## PCN – Process Change Notification

Change:	AA.162.151421.gn
Date:	2016/05/25
Author	Kim Ho

Model#	Part Number	Changes
AA.162 Ulysses Mag Mount Antenna with 1.5M RG174 SMB(F)Plug-3M Disc& Adhesive Heatshrink	AA.162.151421.gn	Packaging rules changing.
		Connector tolerances

### Illustration of Change

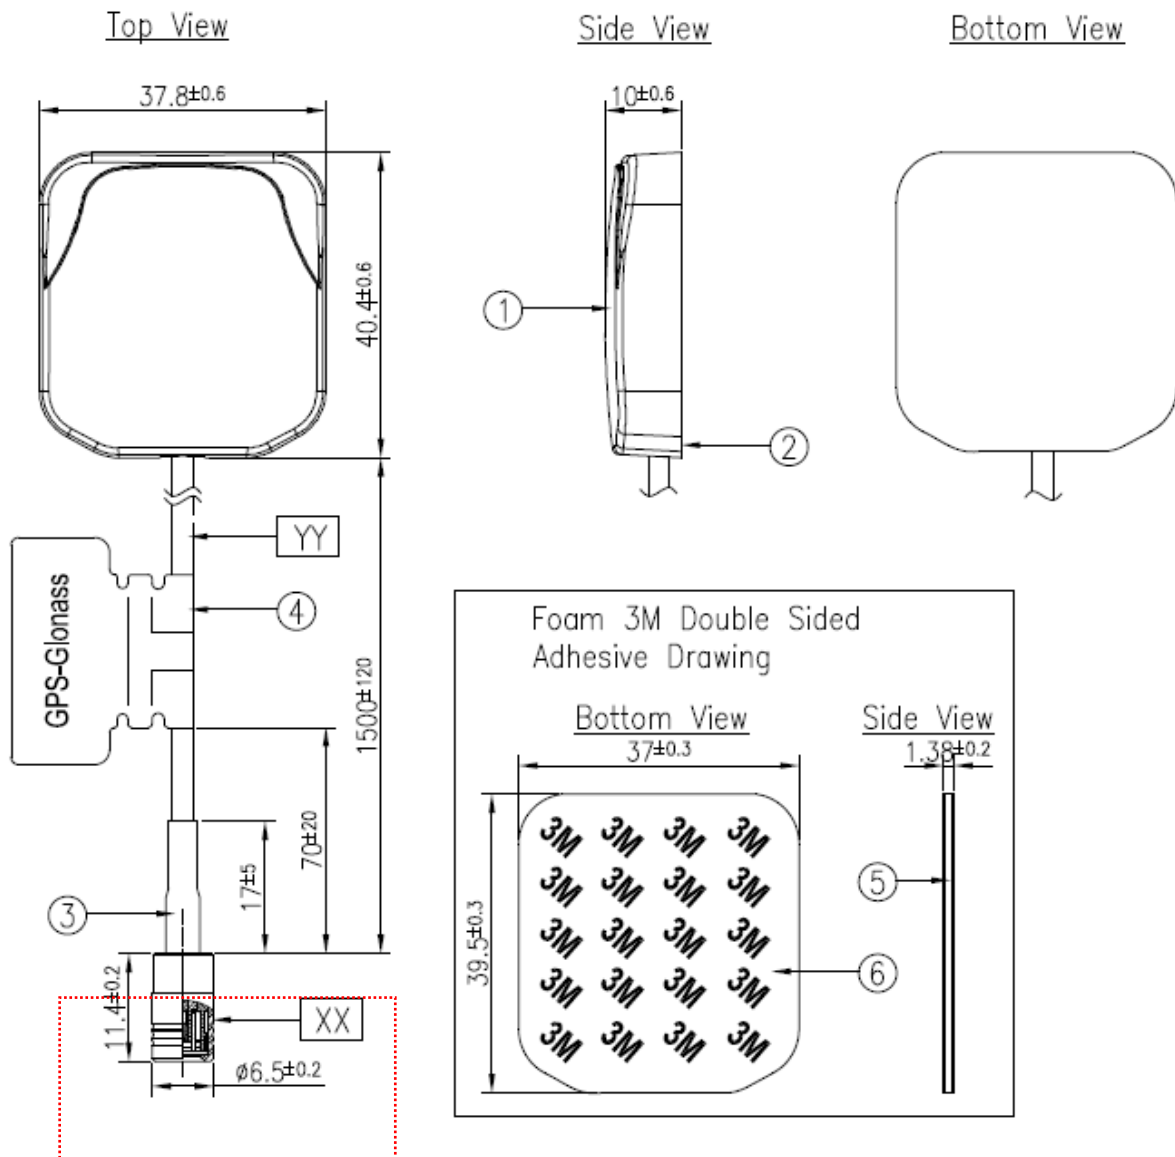
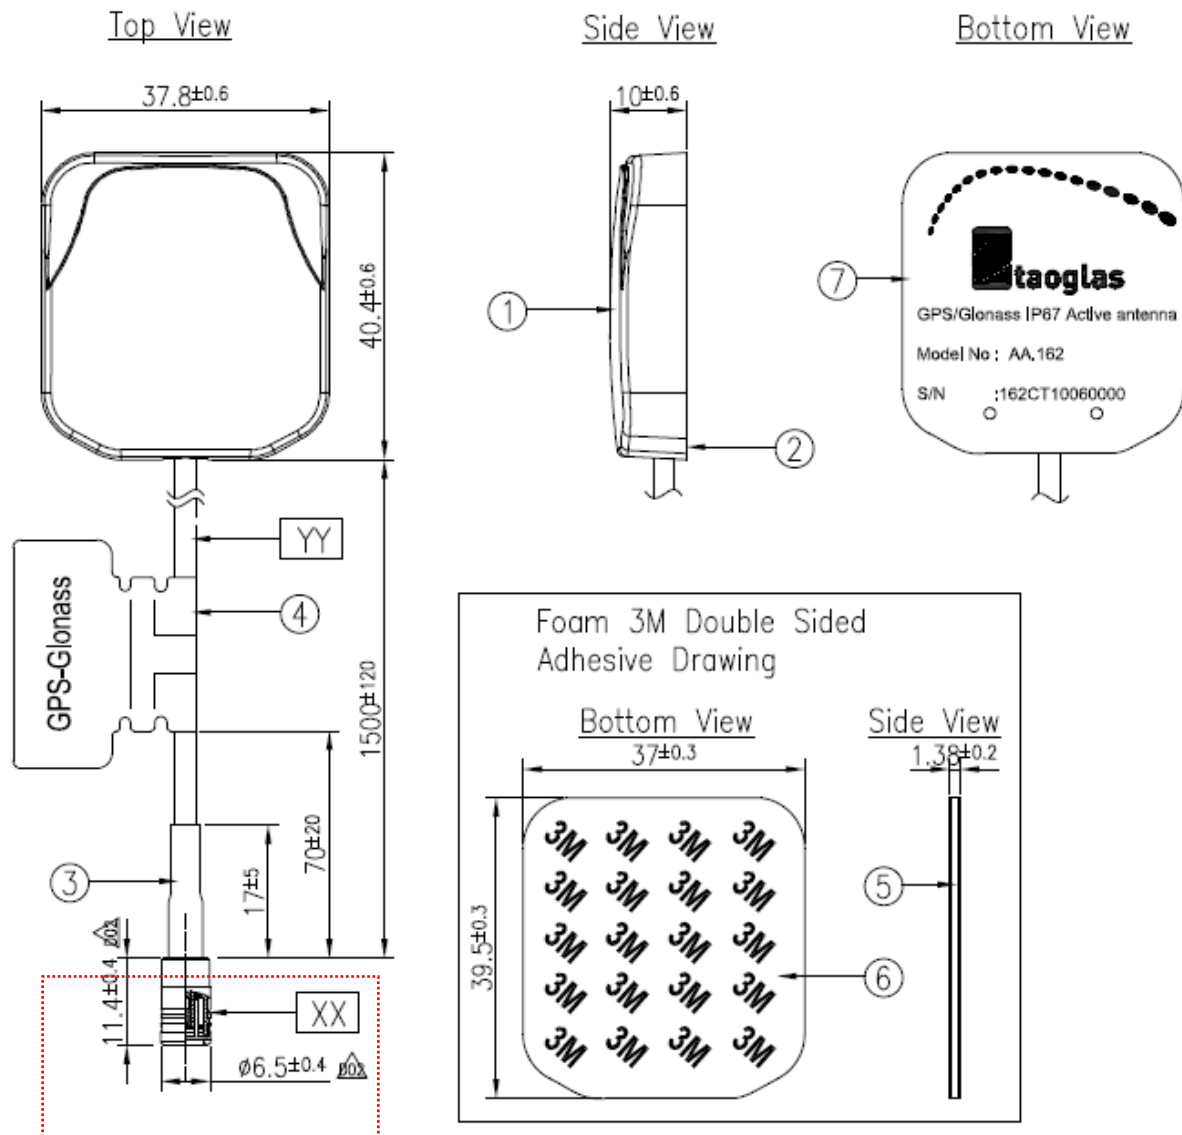
1. Due to Taoglas will input Barcode tracking process, we need to amend the packaging rules and labelling on barcode labels on standard packaging quantity bag and cartons.
2. Relax the tolerance from +/-0.2 to +/-0.4
